221 - 229 Numurkah Road, Shepparton Shopping Centre Development

Shopping Centre Development

Transport Impact Assessment

Client: Greater Shepparton City Council

SCALE 0 5 10
SHEET No. DWG No. **G19863-07**

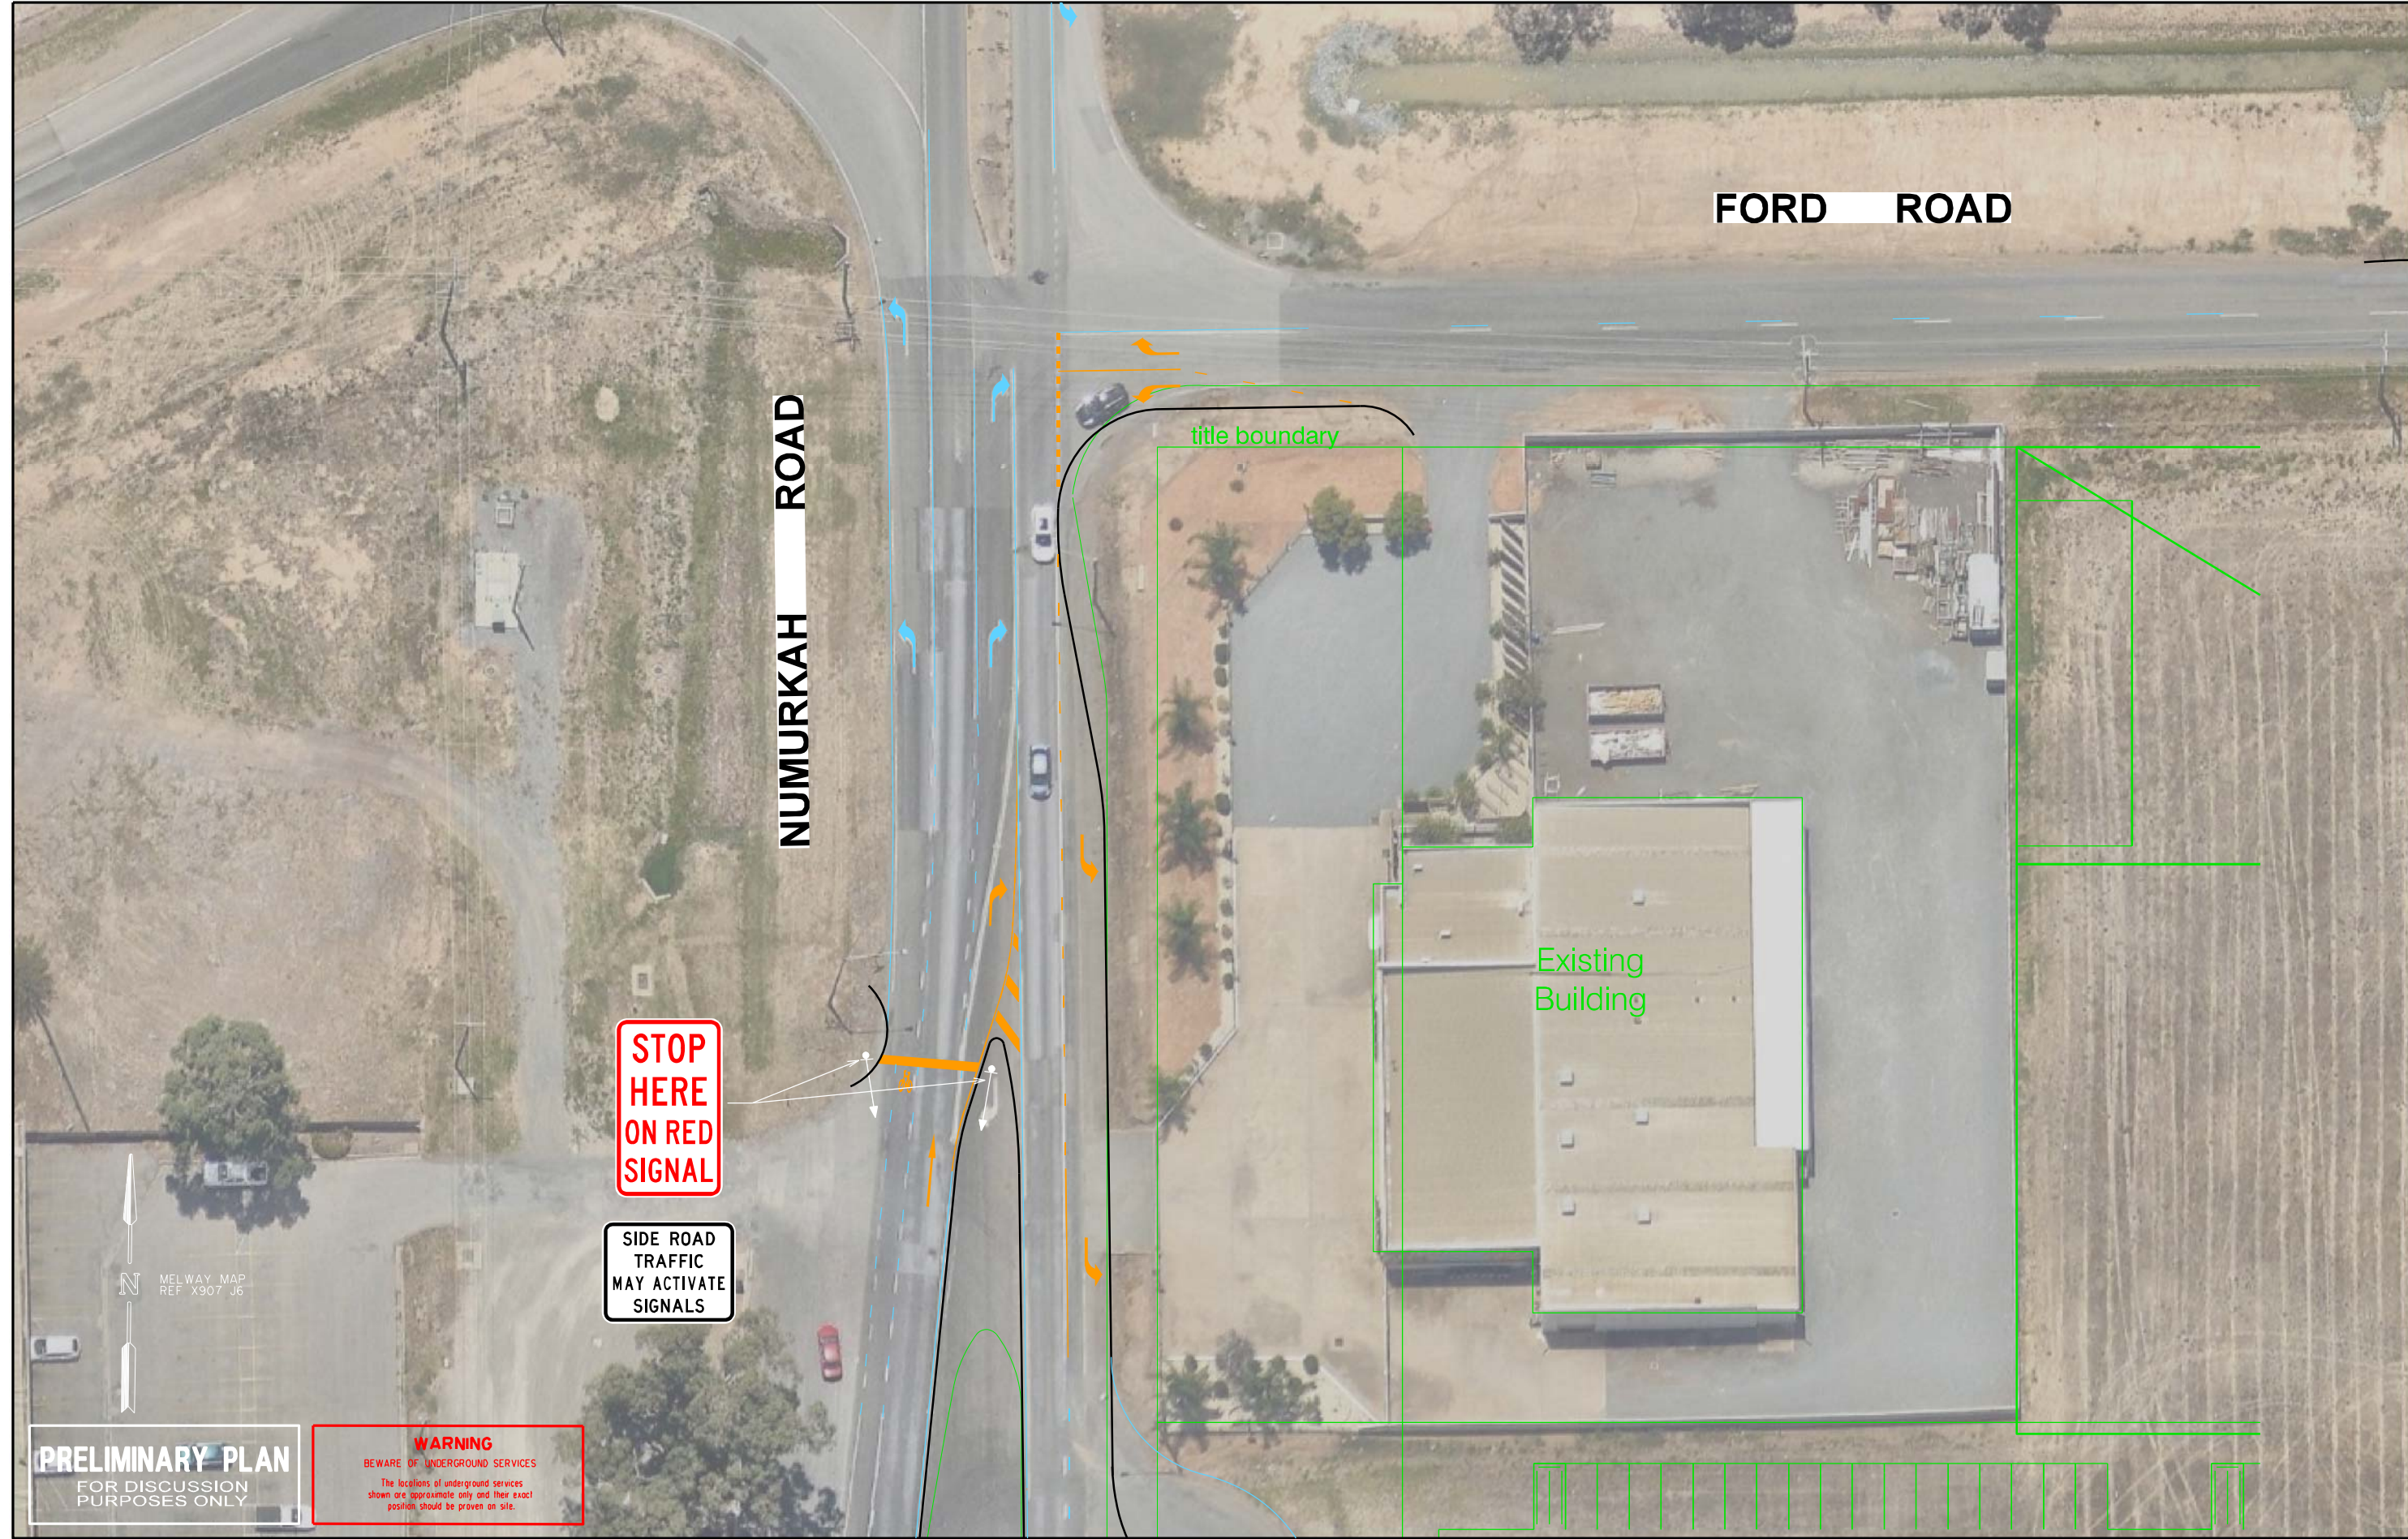
A Concept Layout Plan of the proposed arrangement (Drawing Number 19863-07) dated 30th November, is attached at Appendix A.

For the purpose of our analysis, we have assumed that at the time of peak demand for Ford Road right turns, the signals will provide Goulburn Valley Highway with green time for $\frac{2}{3}$ of the peak hour with a cycle time of 60 seconds.

Functional Layout Plan Mark-Up

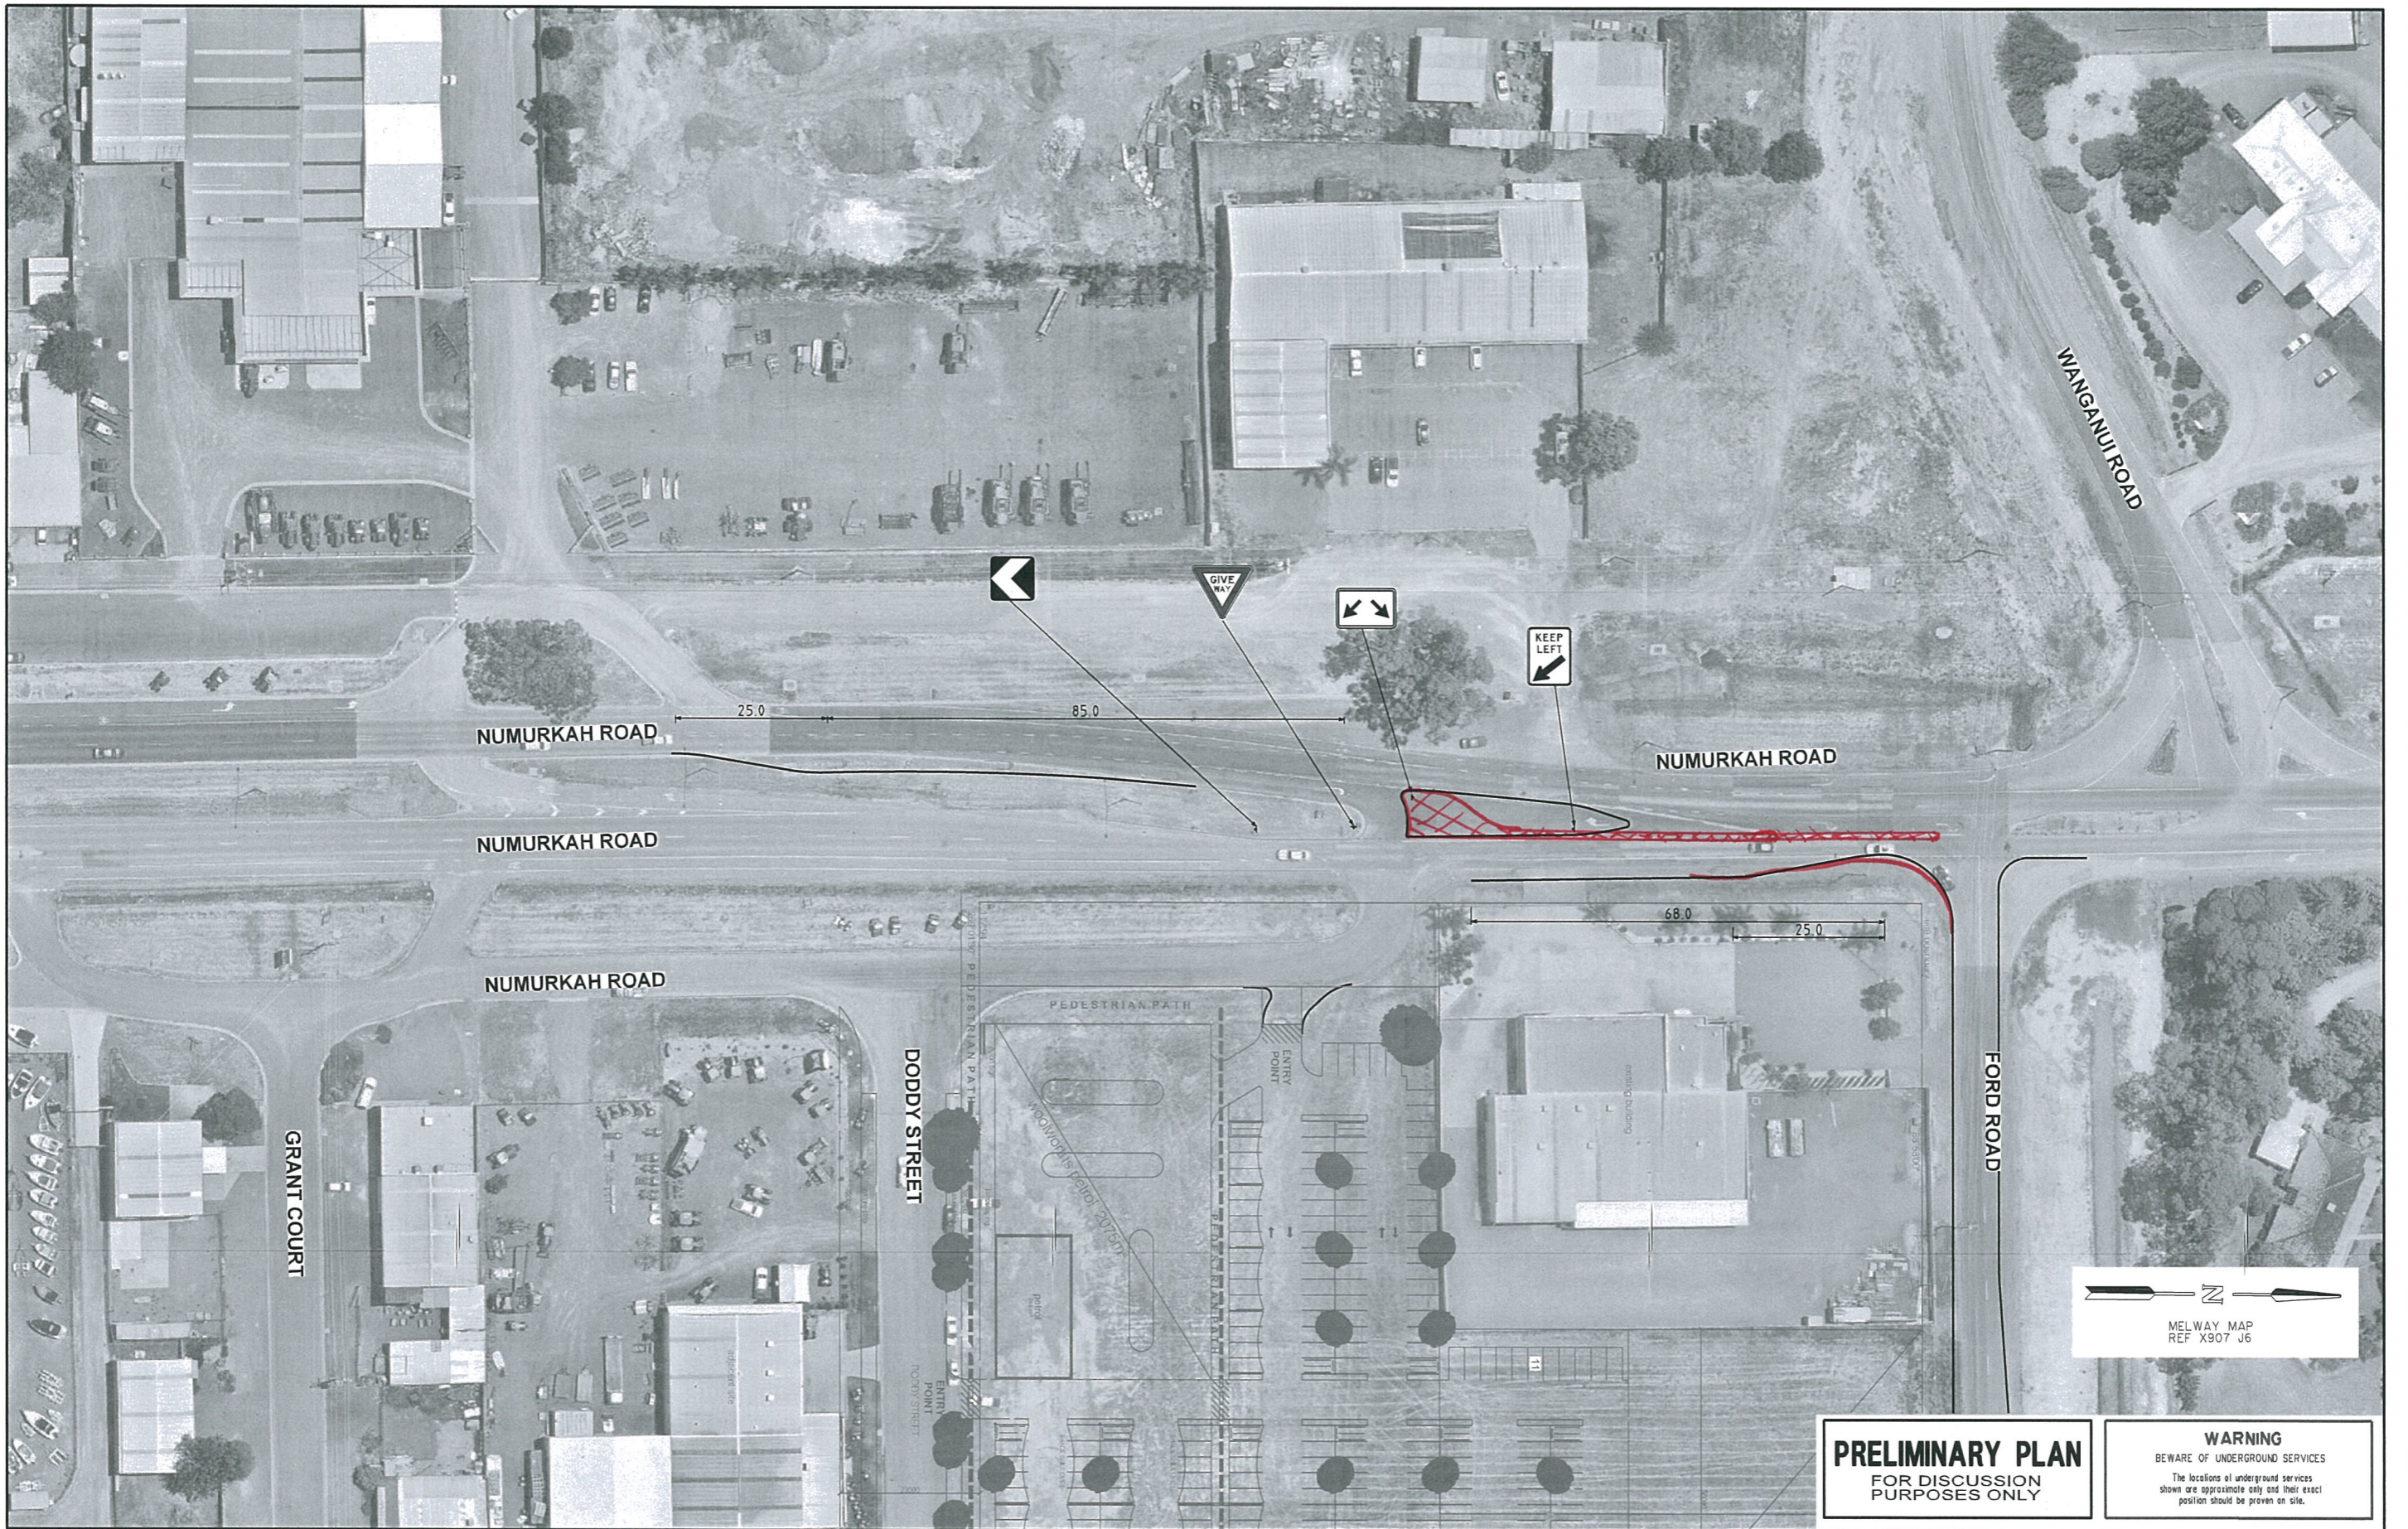
- The proposed intersection layout for the Numurkah Road access point does not include an island north of the right turn from Goulbourn Valley Highway into the Numurkah Road service road to help separate the three right movements between this location and Ford Road. It is recommended that an island is included to help separate these right-turn movements given the expected significant increase in their use as part of this development proposal.
- A left turn deceleration lane on Goulbourn Valley Highway for southbound vehicles has not been included on the proposed plan for this access intersection. It is recommended that this is provided so as to not significantly impact the through traffic volumes on Goulbourn Valley Highway.

In addition, it is considered appropriate for full turning movements to be available at the two access points from Ford Road. The concept layout plans include deceleration lanes for the left turn movement into both access points, as well as a widening of the eastbound carriageway along the frontage of the site to allow vehicles to pass any queued right turning vehicles (no formal right turn lanes provided). At this stage this arrangement is considered to be appropriate, however with further development of the surrounding area, ability to provide full right turn facilities should be considered.
